MEMORANDUM

SUBJECT: Public Hearing: Application 2016-02 for a conditional use permit to allow a building expansion for Forest Elementary School at 6800 – 47th Avenue North

For the Forest Elementary School Classroom Addition Project located at 6800 47th Avenue North, Crystal Minnesota

SCHEMATIC LAYOUT & LANDSCAPING PLAN

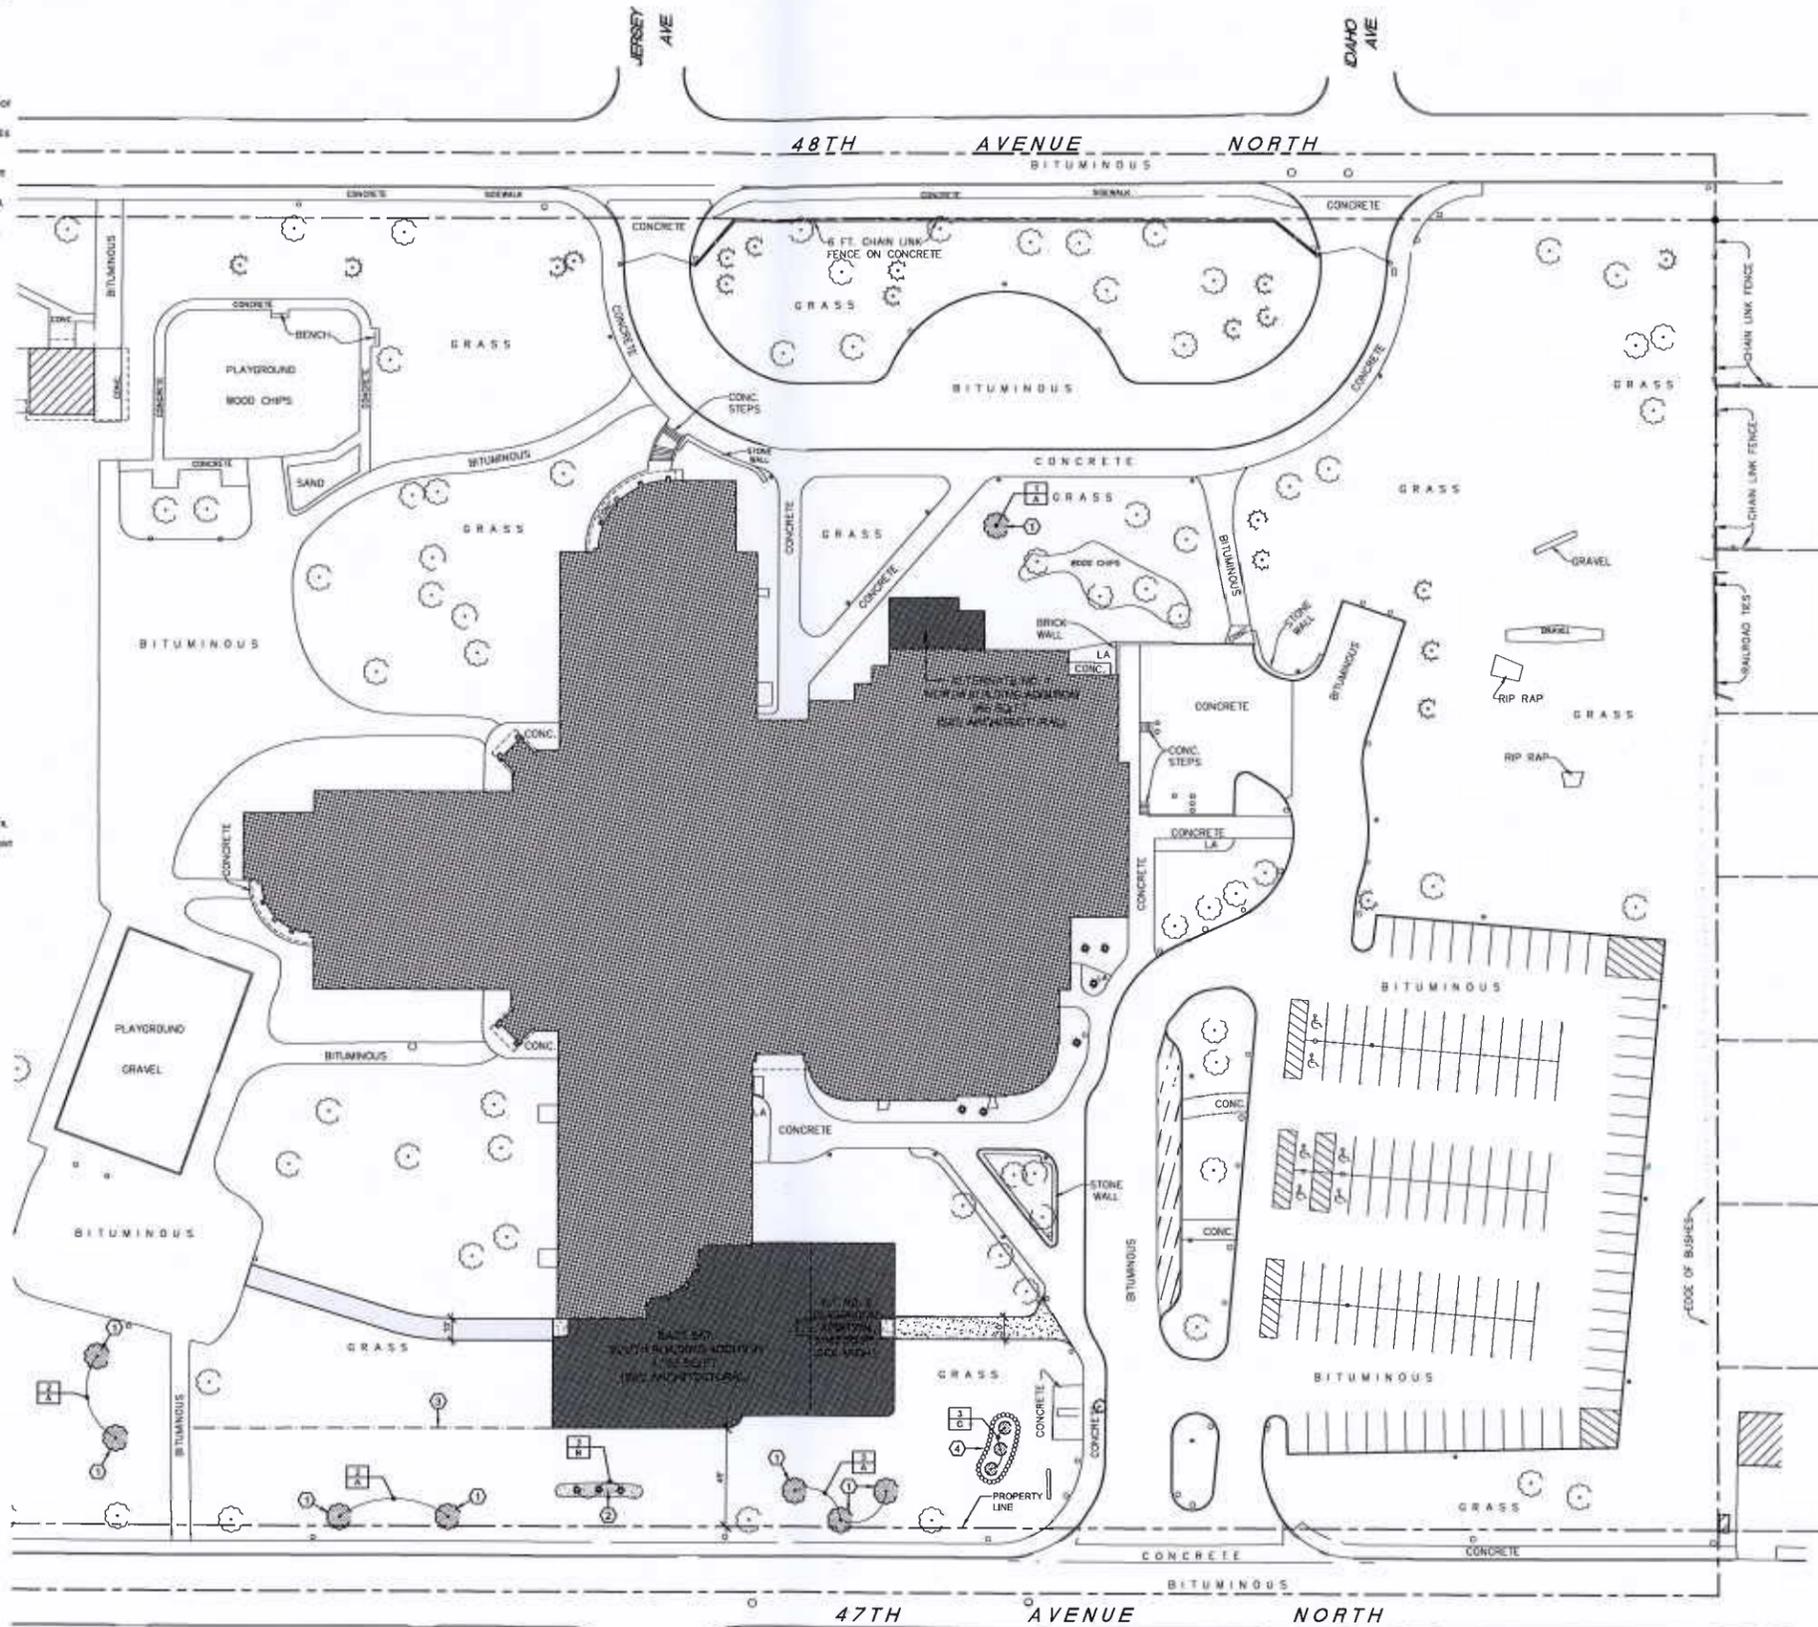
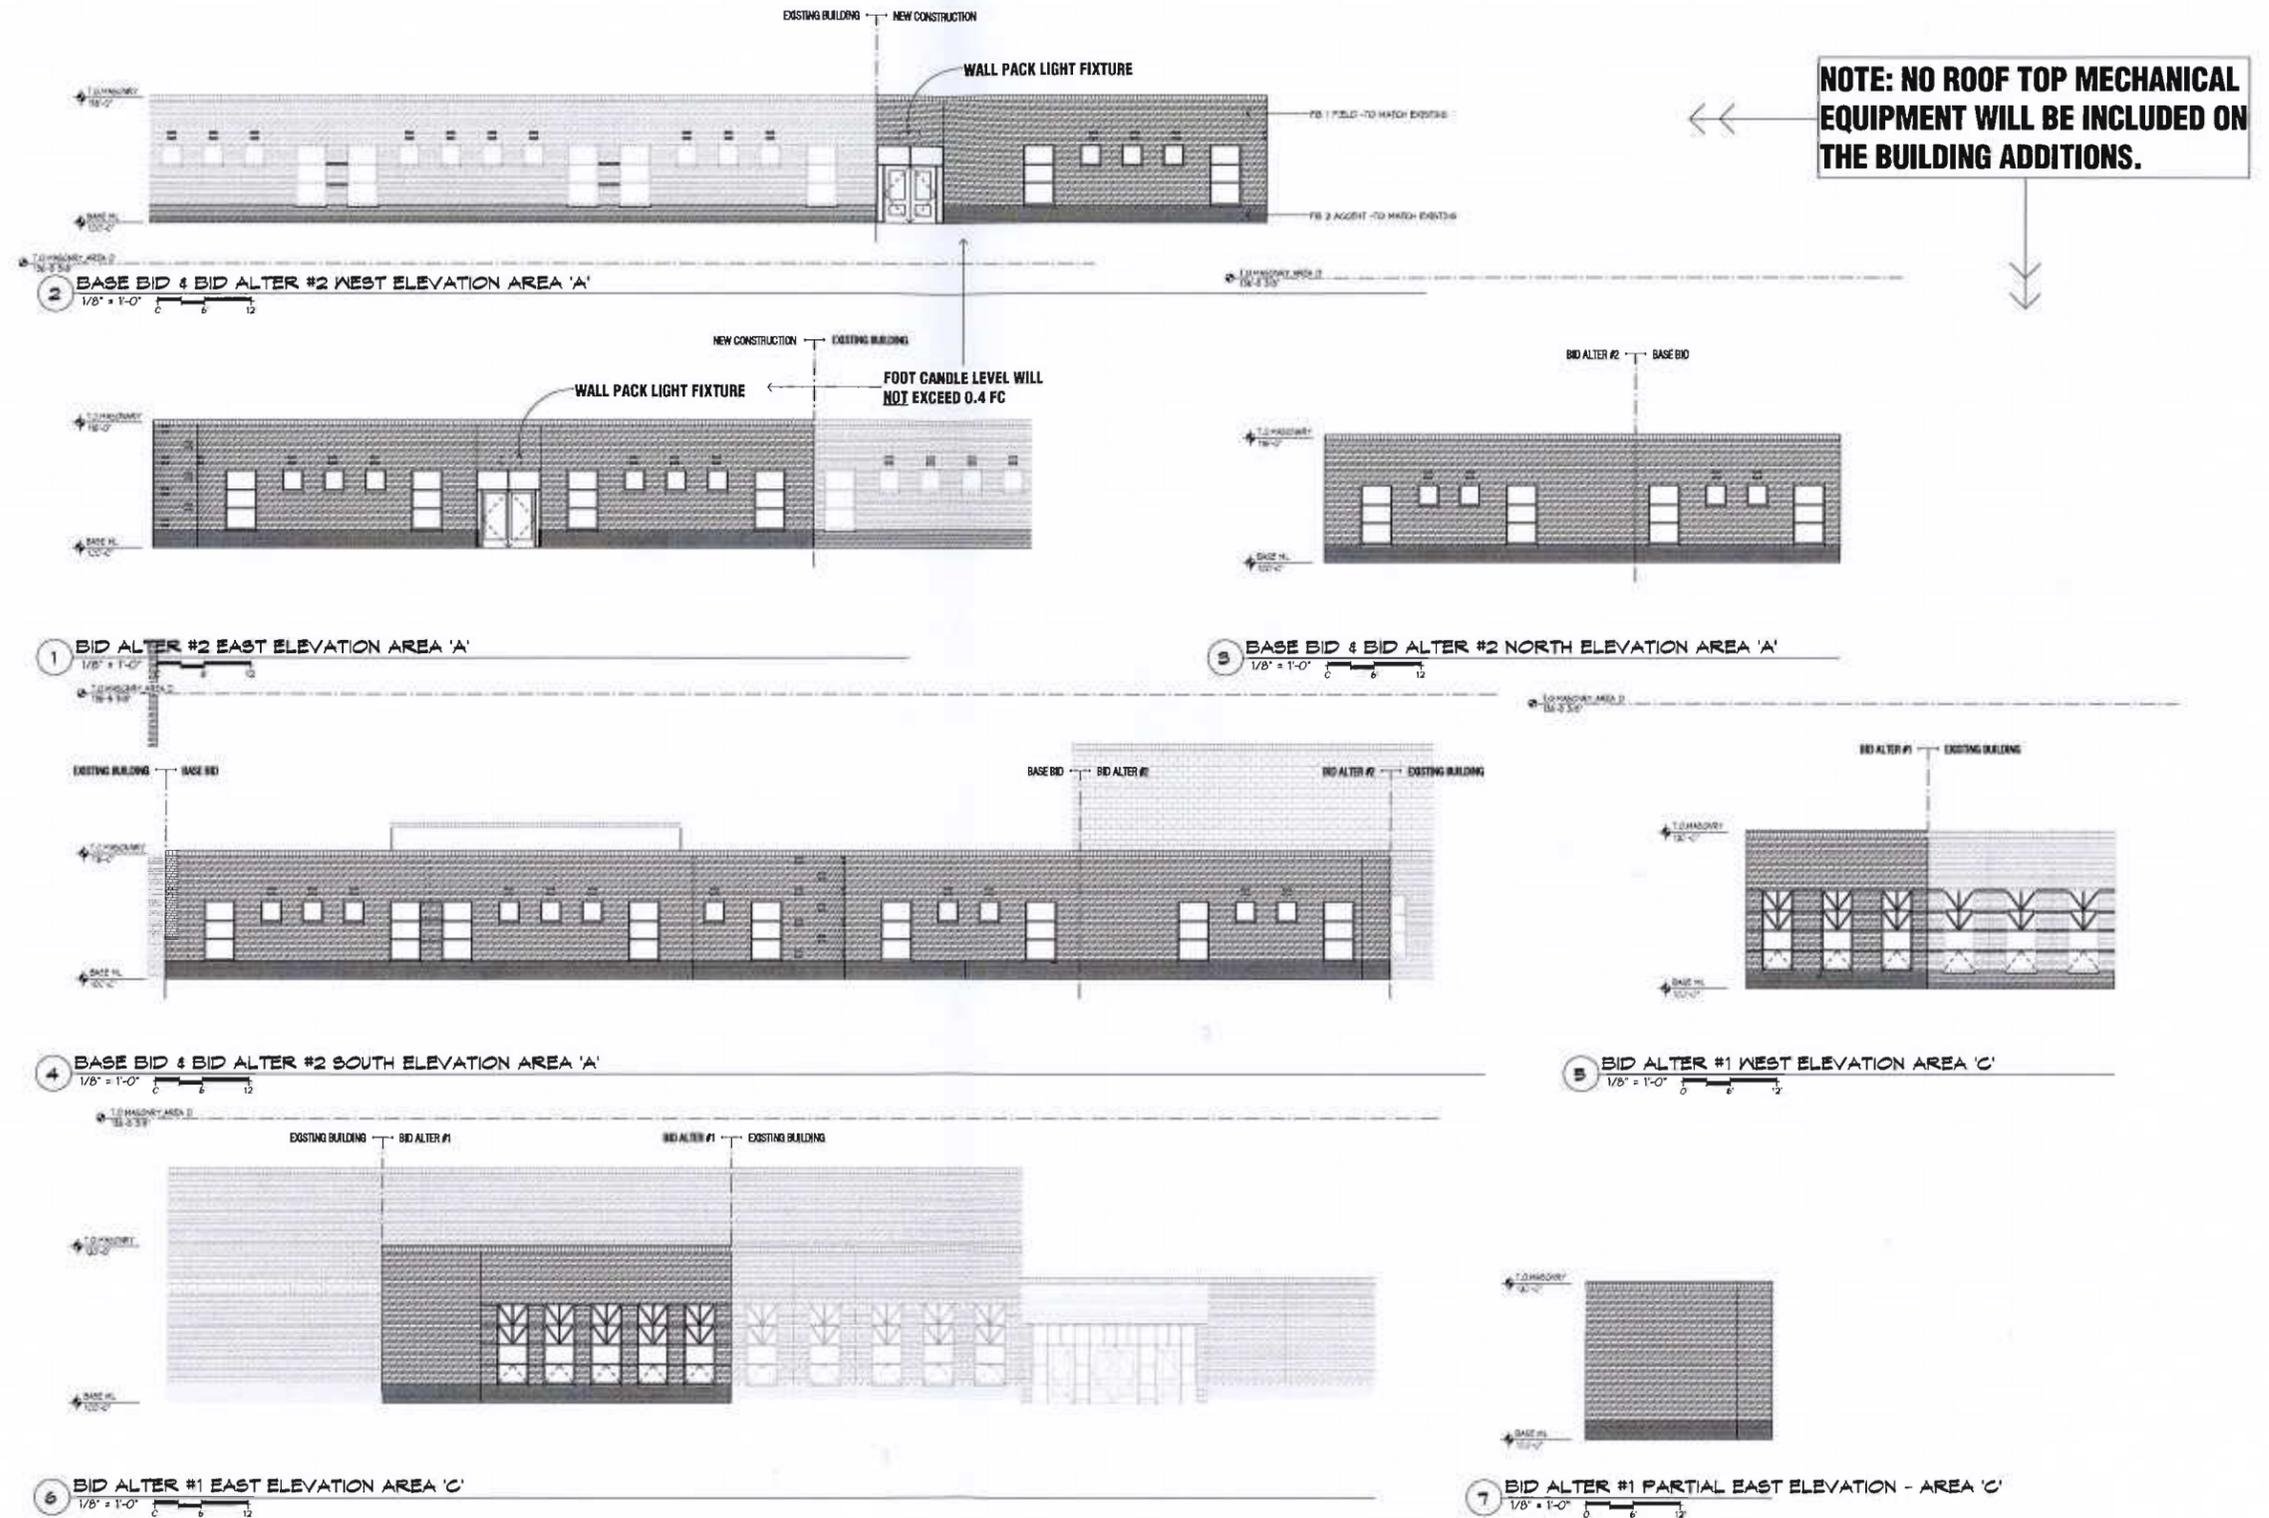
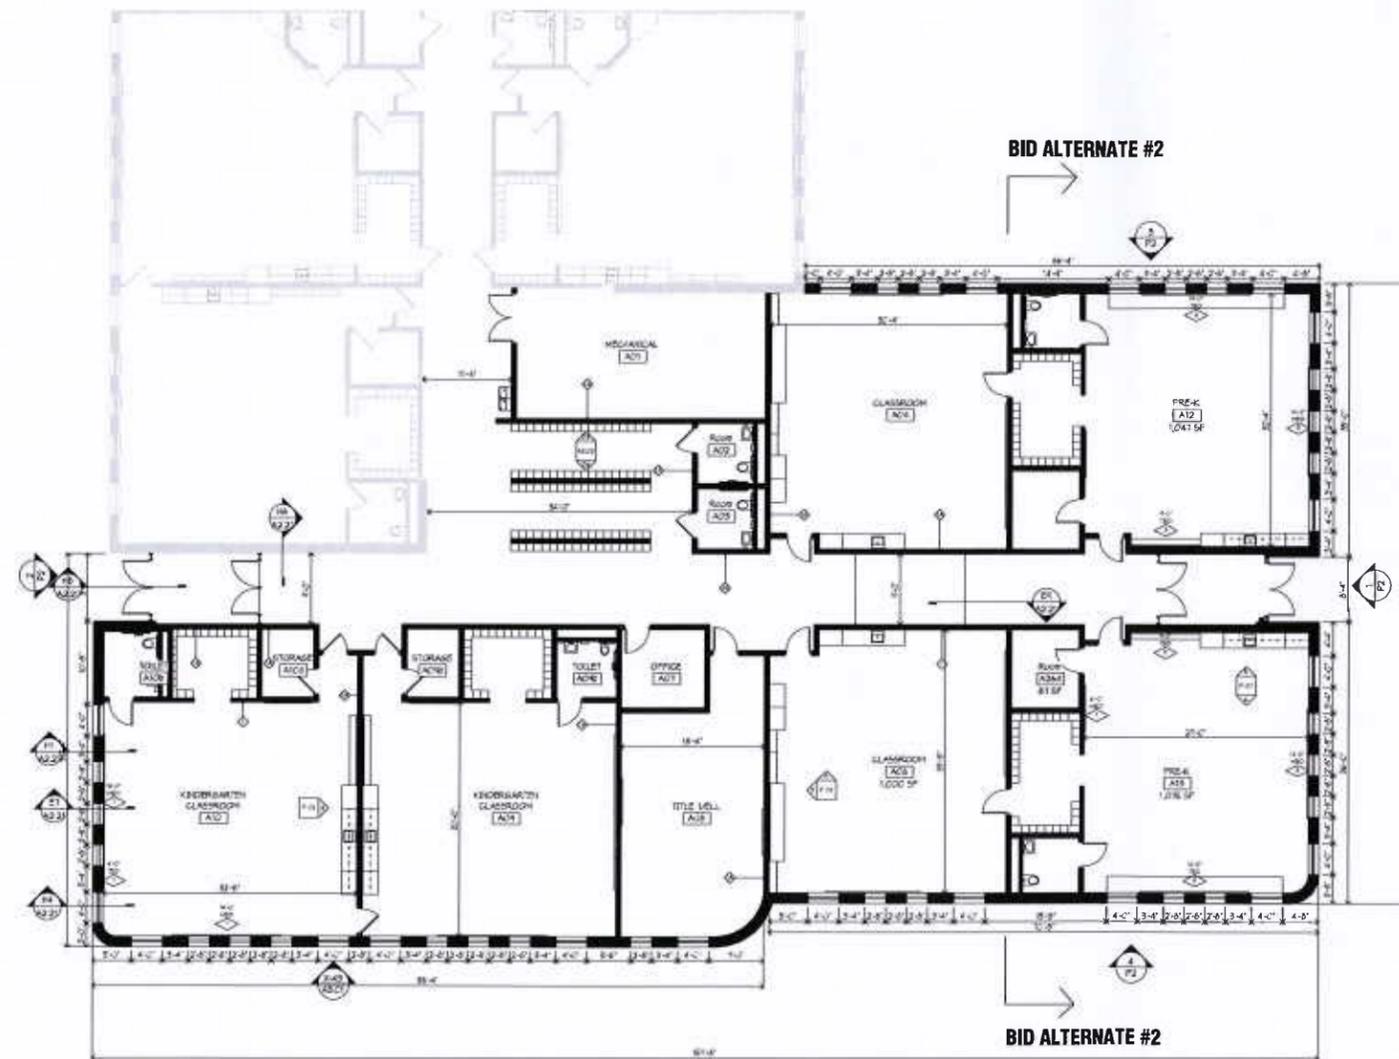
- Landscaping - The landscape plan shows that eleven trees will be removed from the property to accommodate the building additions. Most of these trees are less than 12” in diameter. However two maple trees, one 15” and the other 13” in diameter, are proposed to be removed. According to City Code Section 830.11, Subd. 2, a tree over 12” in diameter that is removed must be replaced with either a tree that is at least 5” in diameter or two trees that are at least 3” in diameter. The applicant will be planting eight “American Sentry Linden” trees and three “Japanese Tree Lilacs”. Shrubs to be planted are “techny arborvitae”. Since the applicant did not show correctly sized trees on their landscape plan to meet the City's tree replacement requirements, staff recommends that the submittal of a revised landscape plan be made a condition of approval of the CUP.

1. The relevant conditions from the 2004 CUP approval are still in effect.
2. The applicant will submit a revised landscape plan that meets the City's tree replacement requirements.
3. The City will monitor the bus loading and unloading areas to ensure that bus circulation does not negatively impact the neighboring residential areas. The City may require changes to these areas if it is determined that there is a negative impact.
